Title - Sujet UPS System Recapit / Mise à niveau	
Solicitation No. - N° de l'invitation EJ076-132319/A	Amendment No. - N° modif. 002
Client Reference No. - N° de référence du client R.053068.004	Date 2013-01-08
GETS Reference No. - N° de référence de SEAG PW-\$\$\$FG-349-61689	
File No. - N° de dossier fg349.EJ076-132319	CCC No./N° CCC - FMS No./N° VME
Solicitation Closes - L'invitation prend fin at - à 02:00 PM on - le 2013-01-15	
Time Zone Fuseau horaire Eastern Standard Time EST	
F.O.B. - F.A.B. Plant-Usine: <input type="checkbox"/> Destination: <input checked="" type="checkbox"/> Other-Autre: <input type="checkbox"/>	
Address Enquiries to: - Adresser toutes questions à: D'aoust, Jacques	Buyer Id - Id de l'acheteur fg349
Telephone No. - N° de téléphone (819) 956-0616 ()	FAX No. - N° de FAX (819) 953-8335
Destination - of Goods, Services, and Construction: Destination - des biens, services et construction: Environment Canada Environmental Science & Technology Centre 335 River Road Ottawa, Ontario K1A 0H3

ADDENDUM No. 1

UPS System Recapitalization

PROJECT No. R.053068.004

ESK-002

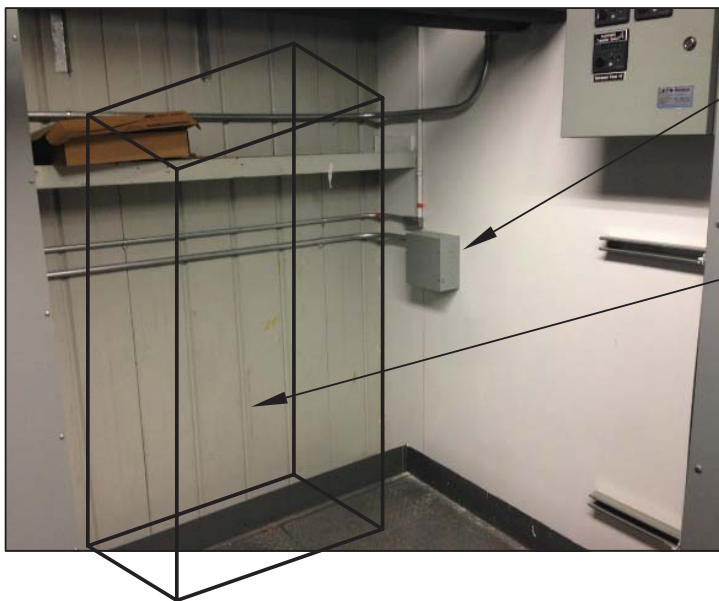
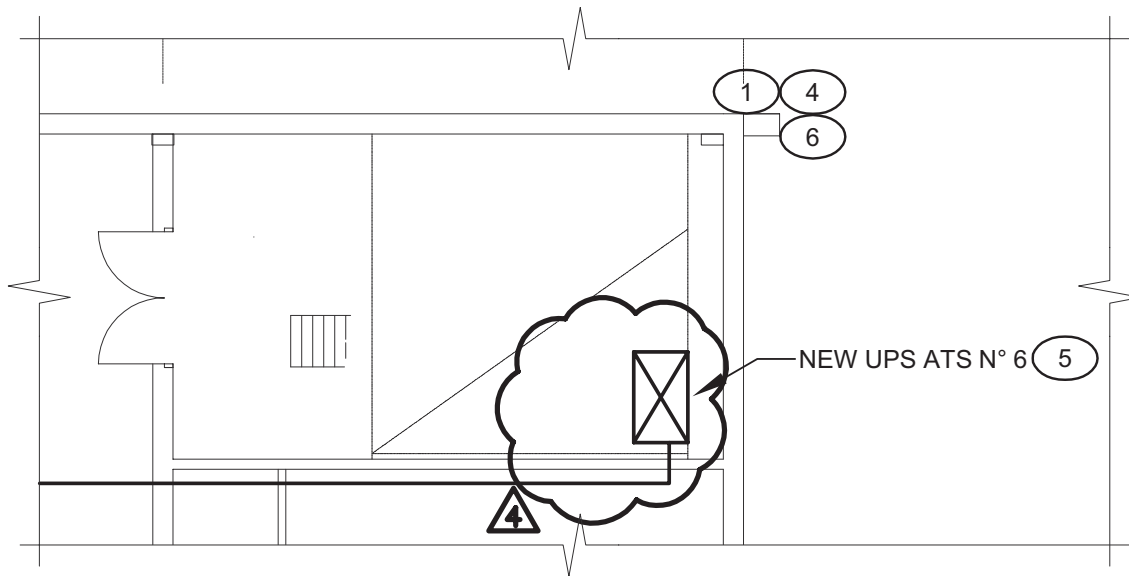
2 Reference drawing E2 – Room Details

- .1 **ADD;** Notes 14 & 15 to Drawing notes with the following (as indicated in ESK-002):

- 14 THE DISTANCE FROM DP-130 IN SERVICE CORRIDOR "D" TO EP-99 IN THE ELECTRICAL ROOM OF THE NORTH WING IS APPROXIMATELY 180m.
- 15 LOCATION OF THE RELOCATED DISCONNECT SWITCHES (DS-180 AND DS-186) FROM THE UPS ROOM.

- (14) - THE DISTANCE FROM DP-130 IN SERVICE CORRIDOR "D" TO EP-99 IN THE ELECTRICAL ROOM OF NORTH WING IS APPROXIMATELY 180m.
- (15) - LOCATION OF THE RELOCATED DISCONNECT SWITCHES (DS-180 AND DS-186) FROM THE UPS ROOM.

ESK-001

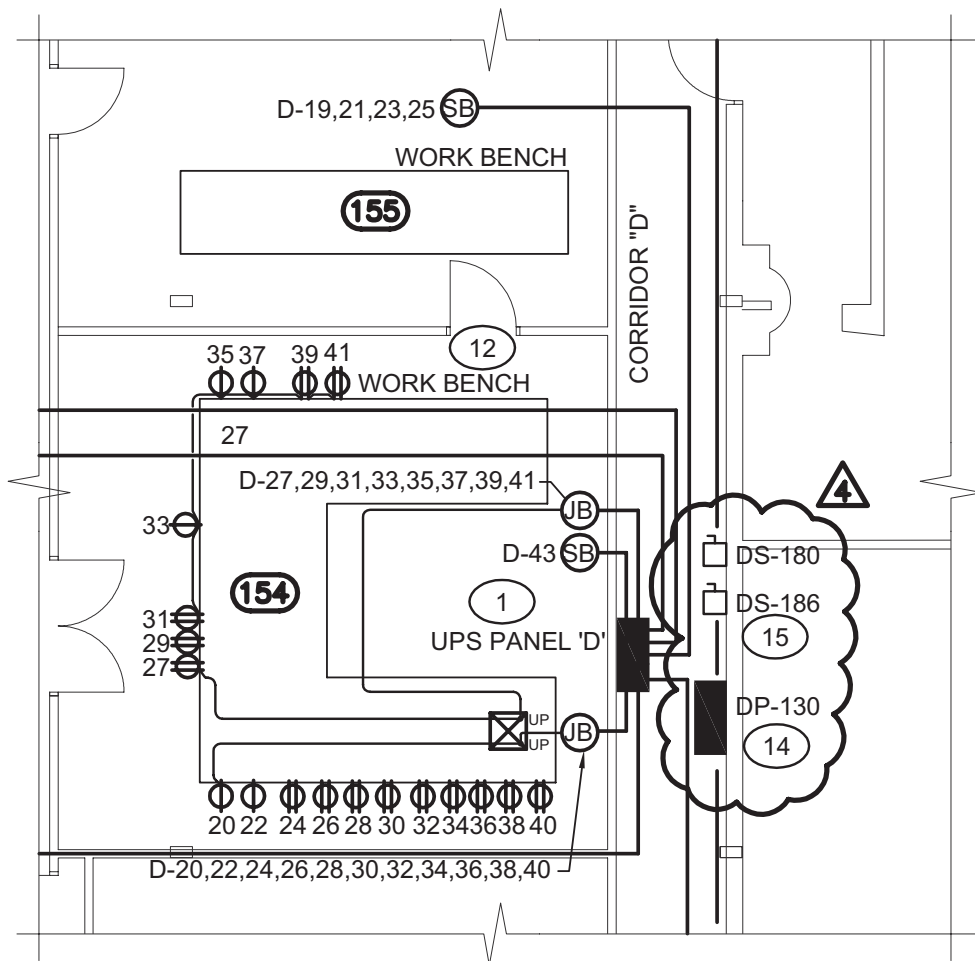
1 Reference drawing E1 – Renovated Floor Plans

- .1 **REPLACE;** Note 5 to Drawing notes with the following (as indicated in ESK-001):

- 5 PROVIDE 400A, 600V, 3Ø AUTOMATIC TRANSFER SWITCH (ATS-6) C/W ISOLATION BYPASS SWITCH FOR SOURCE No.1 AND SOURCE No.2. INSTALL ATS-6 ON THE MEZZANINE FLOOR IN THE ELECTRICAL ROOM. PROVIDE SUPPORTS AS REQUIRED. RELOCATE EXISTING JUNCTION BOX, 21mm CONDUIT AND CAT 5 CONTROL CONNECTION TO FACILITATE THE INSTALLATION OF THE NEW ATS-6 TRANSFER SWITCH.

RELOCATE THE JUNCTION BOX, CONDUIT AND 2-CAT 5 CONTROL WIRING.

LOCATION FOR ATS-6.

- 5 - PROVIDE 400A, 600V 3Ø AUTOMATIC TRANSFER SWITCH (ATS-6) C/W ISOLATION BYPASS SWITCH FOR SOURCE No 1 AND SOURCE No 2. INSTALL ATS-6 ON THE MEZZANINE FLOOR IN THE ELECTRICAL ROOM. PROVIDE SUPPORTS AS REQUIRED. RELOCATE EXISTING JUNCTION BOX, 21mm CONDUIT AND CAT 5 CONTROL CONNECTION TO FACILITATE THE INSTALLATION OF THE NEW ATS-6 TRANSFER SWITCH.
